RE: DRC Response Letter
Santa Barbara Isle Rezoning
PZ21 – 13000003

Below are the responses to the DRC comments dated May 12, 2021 for the above referenced project.

FEMA Flood Map

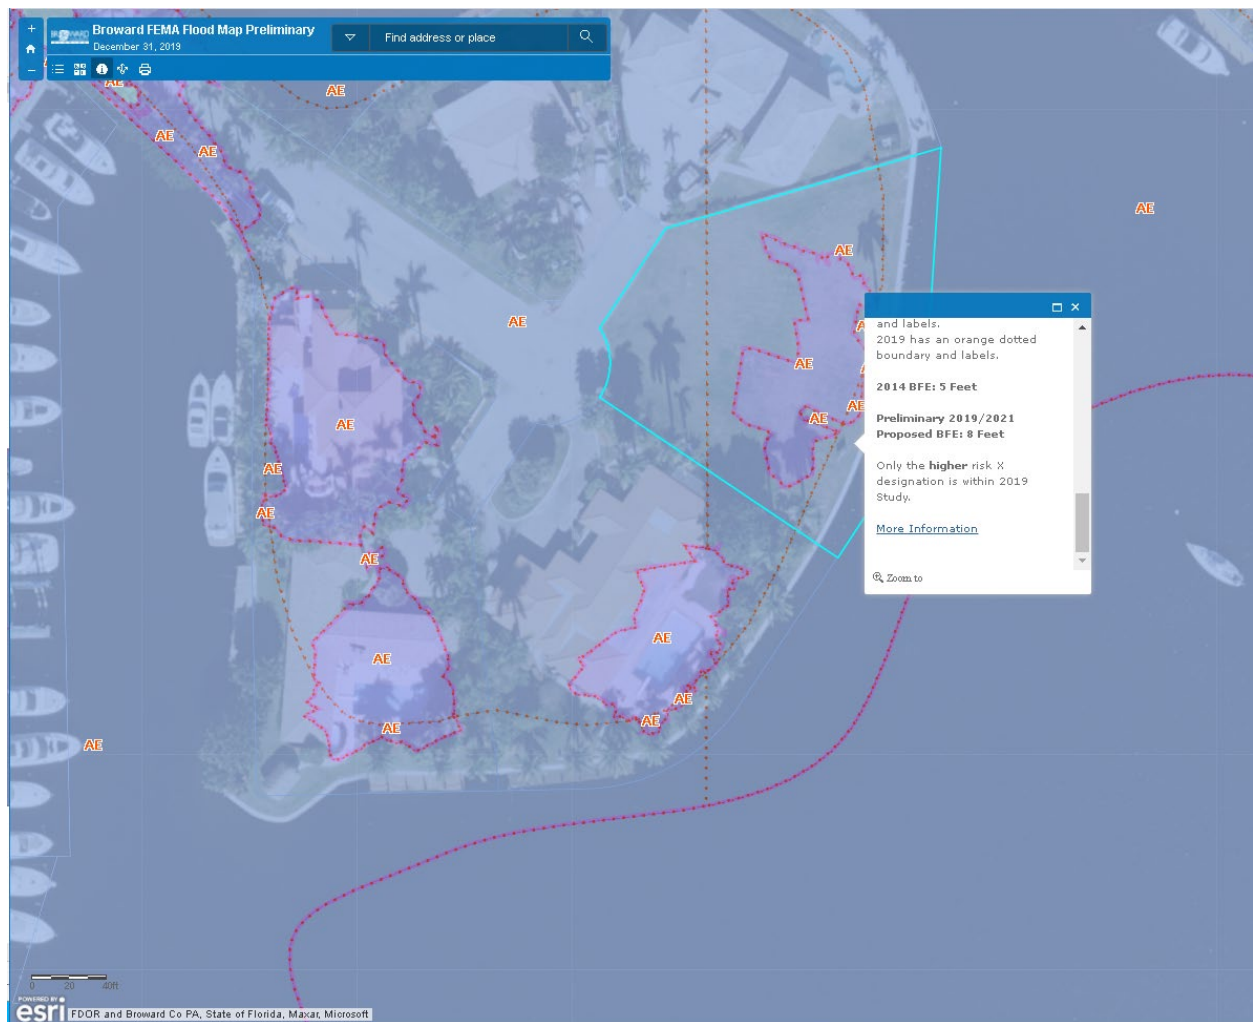
6. This island is particularly vulnerable to sea level rise; therefore in order to consider the full impact of a rezoning approval that would provide for the intended result of 4 new structures being constructed, conceptual site plans and elevations will be necessary. The applicant shall provide a conceptual site plan and building elevations for all 4 lots being created, which demonstrate how the finish floor elevations will be designed and elevated above the projected 3’ of sea level rise without flooding the adjacent lots. These building elevations and site plans must be shown to the other 4 lot owners/residents at the neighborhood meeting prior to the Planning and Zoning Board Hearing.

Response: This property is in the tidal coastal stormwater basin of the Atlantic Ocean located approximately 0.25 miles west of the Intracoastal waterway and 3 miles south of the Hillsboro Inlet. The current 2014 FEMA Base Flood Elevation (BFE) is 5.0 Ft, NAVD88.

The Preliminary 2019/2021 Proposed BFE is 8.0 Ft. NAVD88.

Finished floor elevations for the proposed structure will be set at a minimum of (9.0 Ft. NAVD88, per Florida Building Code (FBC) requirement of BFE + 1. Ft.

Per FBC, the design of the site shall insure that no stormwater will sheet flow onto adjacent property.

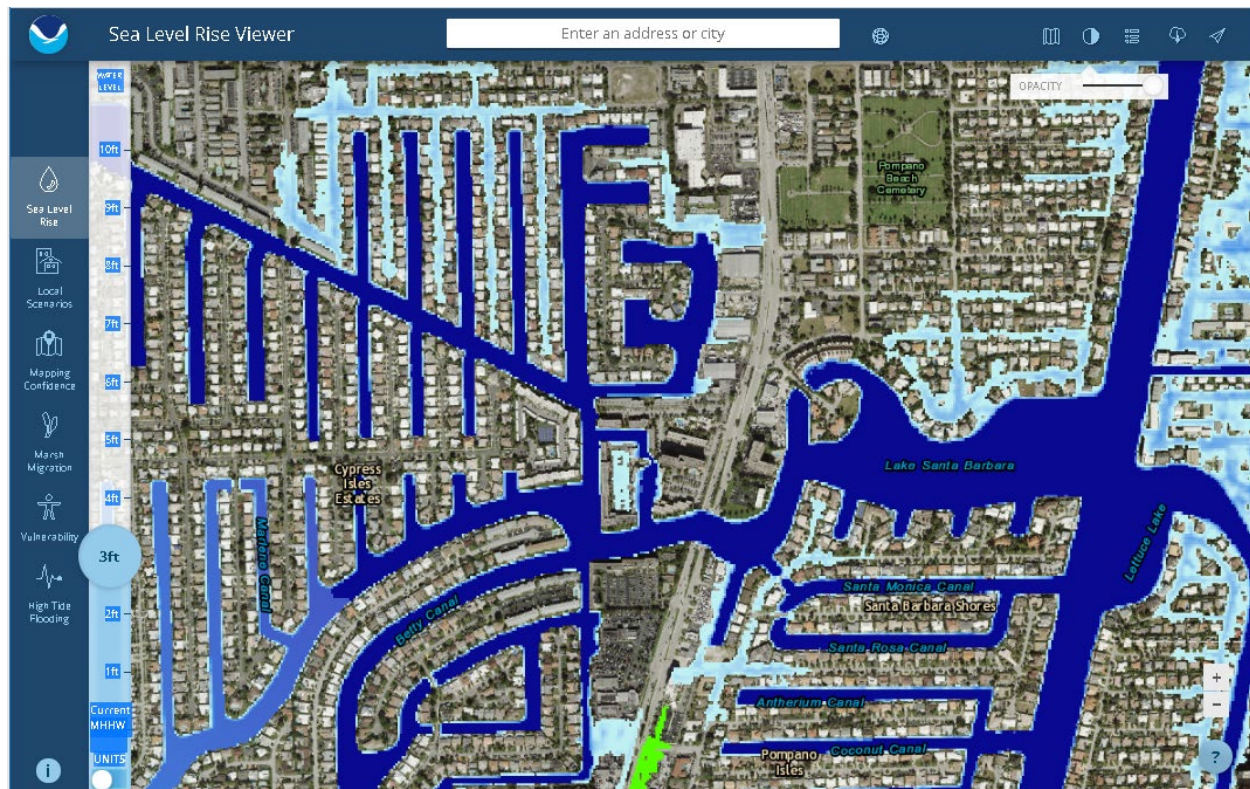
7. The attached Maps show the potential impact that sea level rise (SLR) could have on this area and the possible impact of SLR in combination with a major rain event.

The NOAA Sea Level Rise viewer for 3 ft. of sea Level Rise indicates minimal effect on the Island [Sea Level Rise and Coastal Flooding Impacts \(noaa.gov\)](#):
